CROSSROADS MIXED USE FILING NO. 1

CONSTRUCTION PLANS

DECEMBER 2021

EL PASO COUNTY FILE NO. SF 21-029

STORM 4.1 (PRIVATE)
STA 1+00.00 TO STA 1+94.00

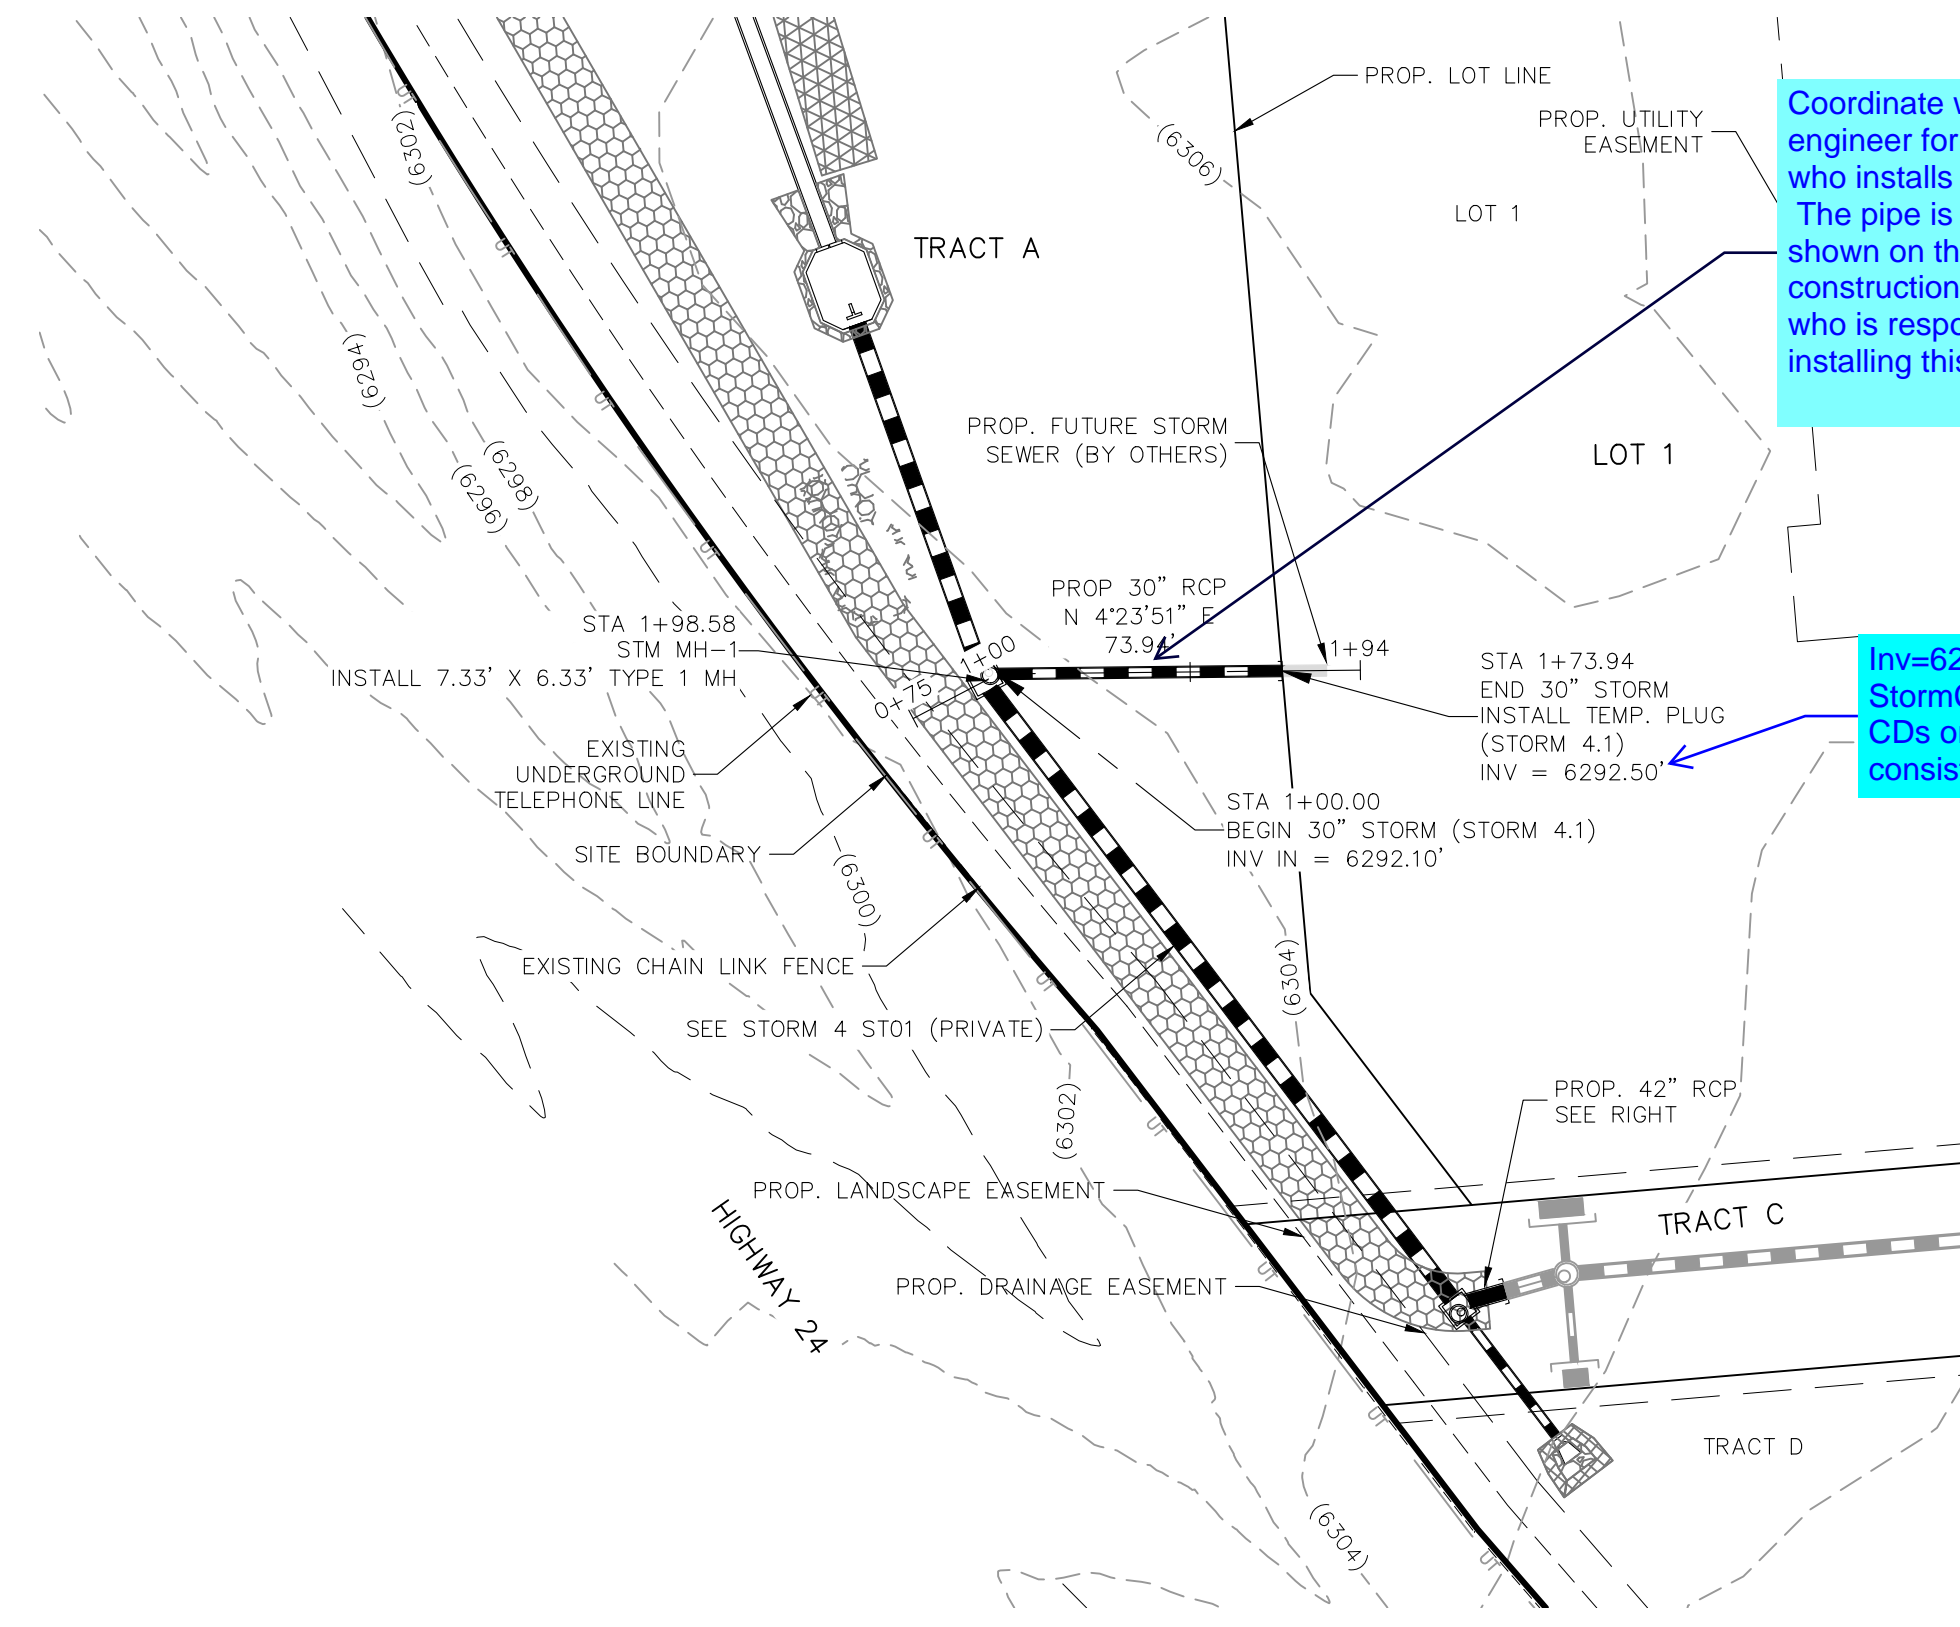
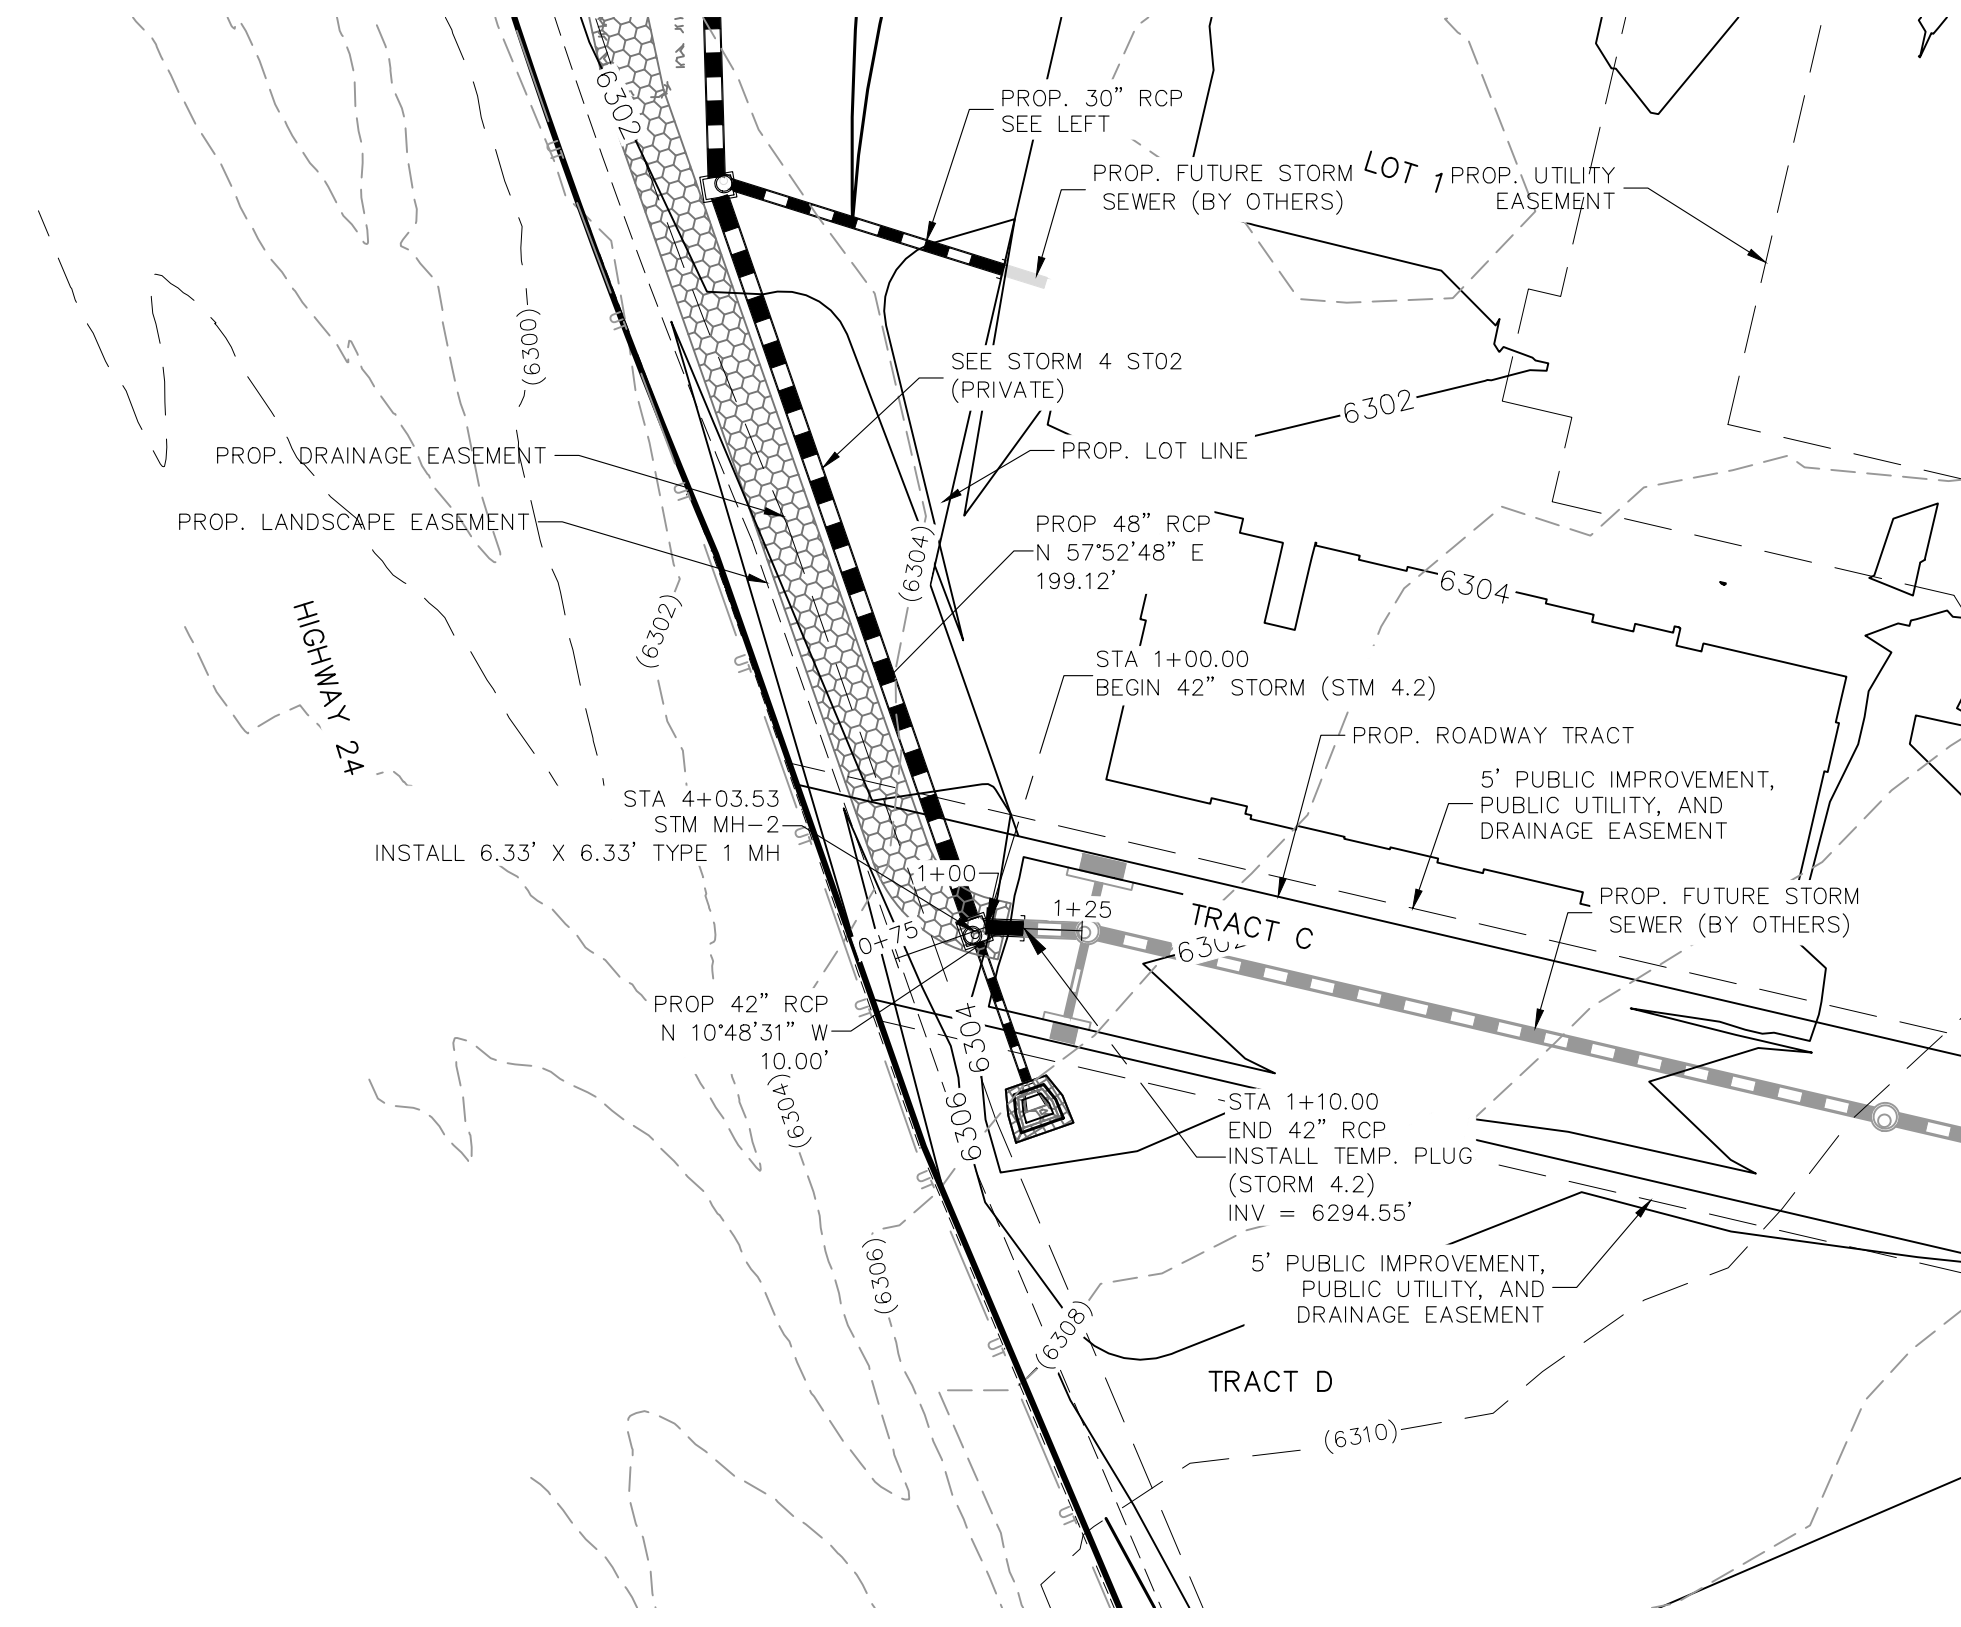
Coordinate with the engineer for Aura on who installs this pipe. The pipe is also shown on their construction. Unclear who is responsible for installing this pipe

Coordinate with the engineer for the Aura site plan. Both construction plans does not match either the invert, pipe size or both

STORM 4.1 (PRIVATE)

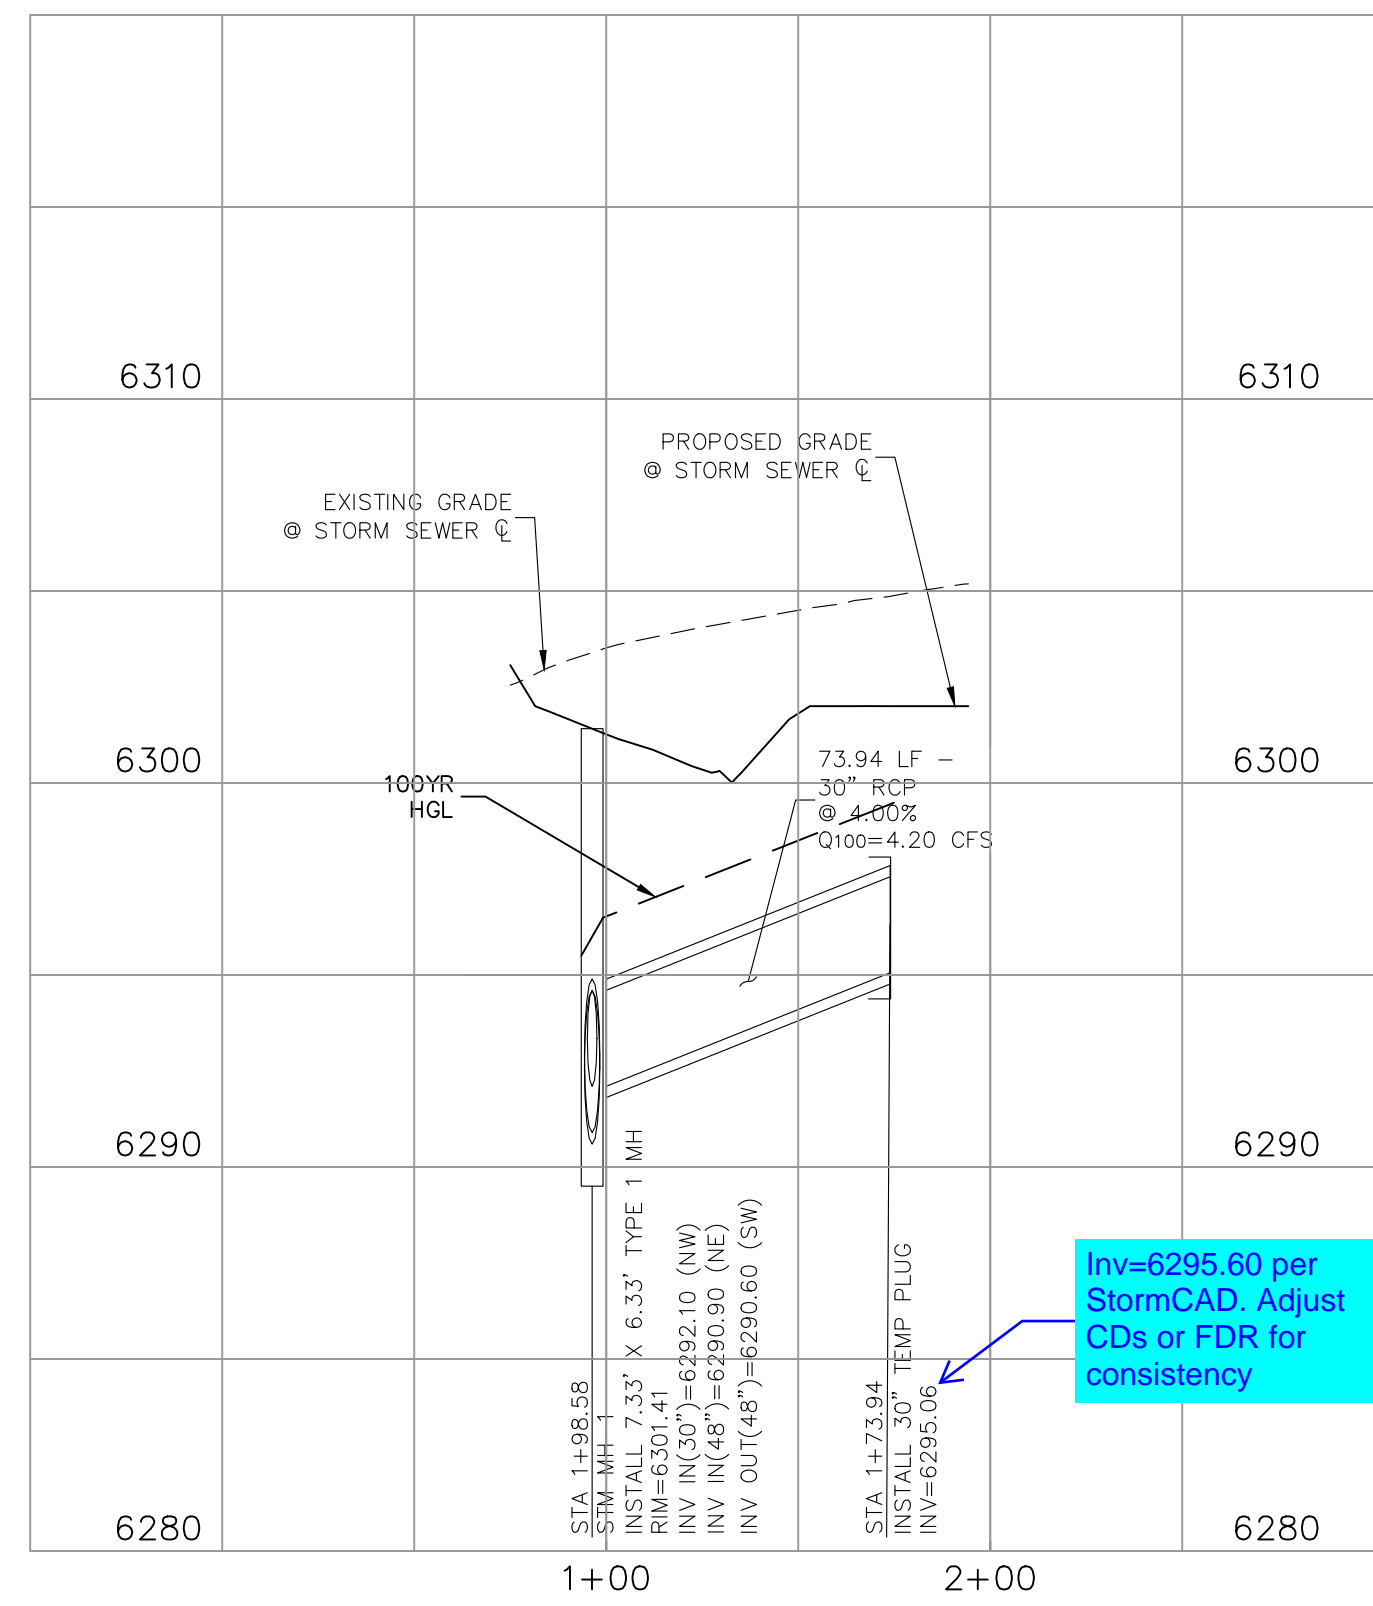
Inv=6295.60 per StormCAD. Adjust CDs or FDR for consistency
